SOUTHERN CALIFORNIA RAPID TRANSIT DISTRICT
METRO RAIL PROJECT

**VALUE
ENGINEERING
STUDY #1**

**DESIGN CRITERIA
AND DIRECTIVES
MOS II**

Subject: Value Engineering Study No. 1, MOS II
Design Criteria and Directives

Present Design Contract Packaging

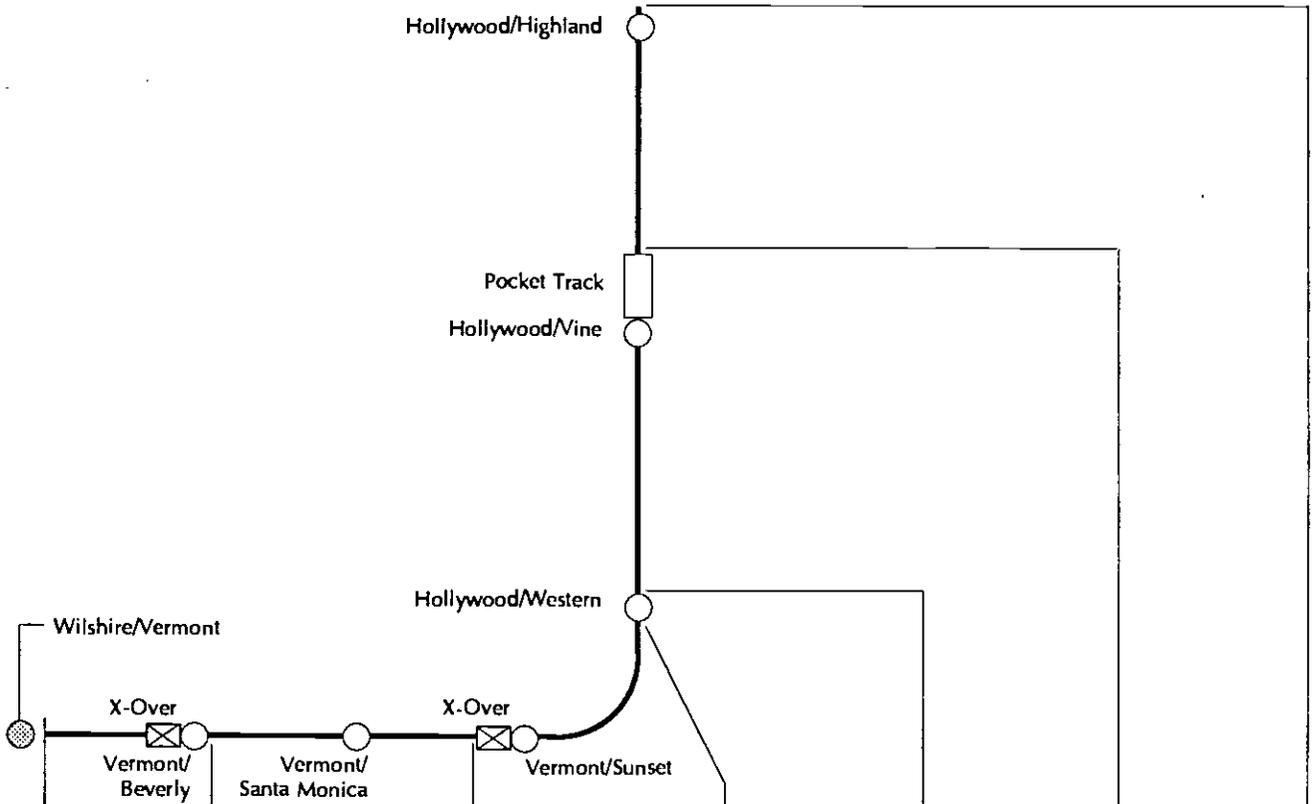
The work is divided into 6 packages including all utility work, landscaping and restoration, tunnels, line structures and one station per package. The station work includes all finishes. Package costs are in the range of \$40 - \$80 million and a single contractor will be responsible for the entire work of the package.

Therefore, the six original packages have been reduced in scope to reflect station, concrete and finish work only, while two tunnel and excavation contracts have been added. The savings in tunnel and excavation work arise from the fact that long mobilization periods are eliminated and contractors overhead costs are halved. The resulting savings represent about 1.4% of project cost. There will also be savings in the purchase and/or rehabilitation of TBM's, projected at \$1.1 million to \$4.1 million.
